PROJECT NAME: MANCHESTER-RUTLAND TOWN	
PROJECT NUMBER: NH SURF(50)	
FILE NAME: p14v200.dgn	PLOT DATE: 1/14/2016
PROJECT LEADER: M. FOWLER	DRAWN BY: B. KIPP
DESIGNED BY: B. KIPP	CHECKED BY: M. FOWLER
TRAFFIC SIGNAL SYSTEM SHEET 1	SHEET 85 OF 105

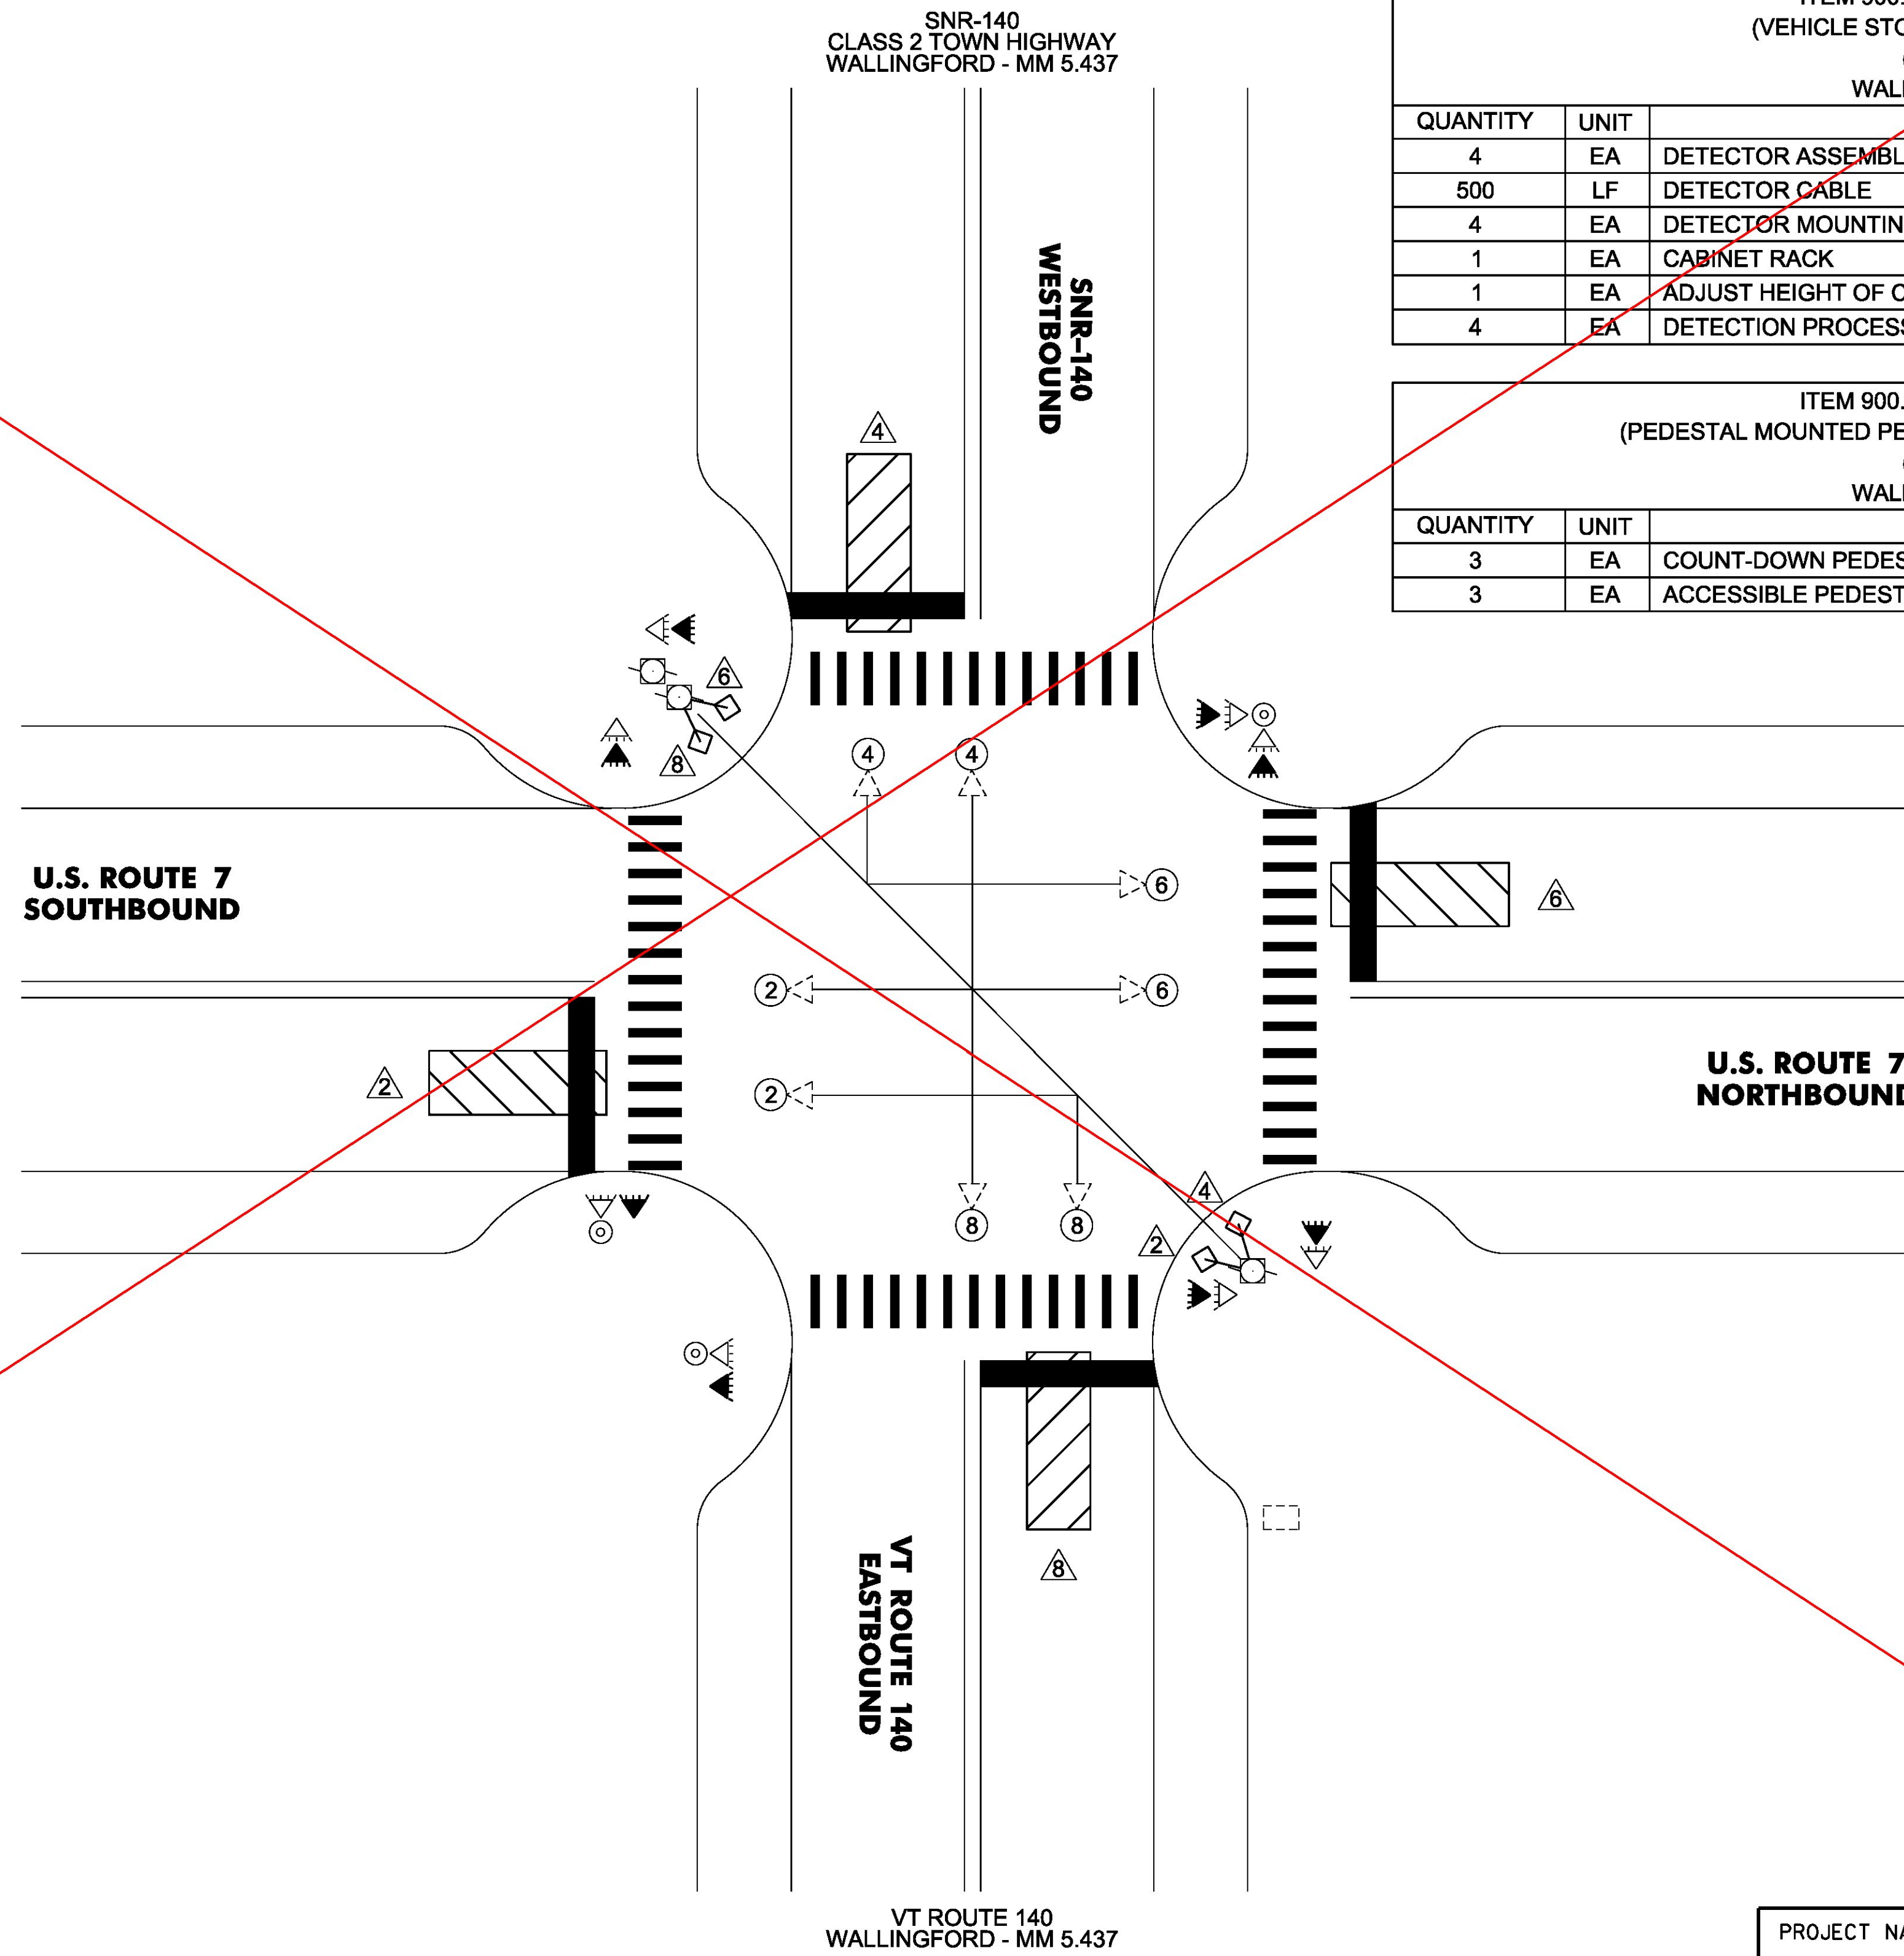
see revised sheet
